# Background Rates in GlueX

March 7, 2007

## 1 Question

Figure 1: Coherent bremsstrahlung photon energy distribution for GlueX. The red curve labeled “3.4mm collimator” is the distribution used when determining the rates in the GlueX detectors.

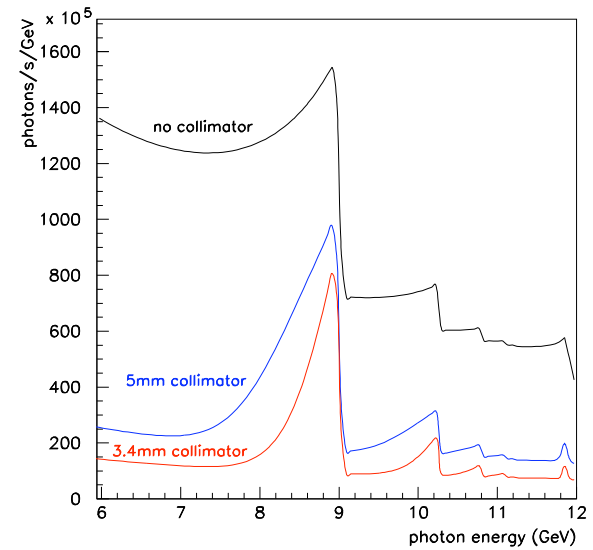
1) What calculation/simulation has been done of the background processes that will dominate the rate in the chambers?

A total of  $10^8$  9 GeV coherent bremsstrahlung beam photons (see fig. 1) were generated using the geometry and simulation current as of January 15. The  $10^8$  beam photons is approximately 1/110 of second of beam time. The events were processed using the GEANT3 simulation with full geometry and all processes turned on, including hadronic interactions.

The dominant process that resulted in rates in the chambers was pair production in the target with some contribution from Compton scattering. Hadronic interactions in the target represent a relatively small contribution to the background rate.
